Technical Bulletin
New Generation POPIT reversed wiring

▶ **D9127T**
▶ **D9127U**

August 20, 2024

Old POPIT   **New POPIT**

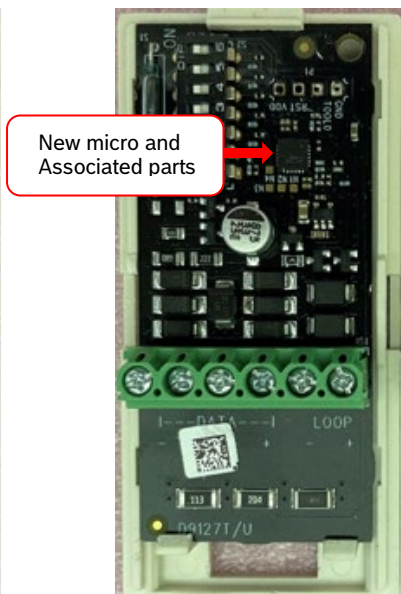
The new generation of POPIT modules will send an "*Open*" status when the bus wiring is reversed. Previous versions of the POPIT module would report "*missing*" if the bus wiring was reversed.

Bosch will update the new POPIT in the near future to provide the same indication of "*missing*" for reversed wiring in order to eliminate any potential confusion.
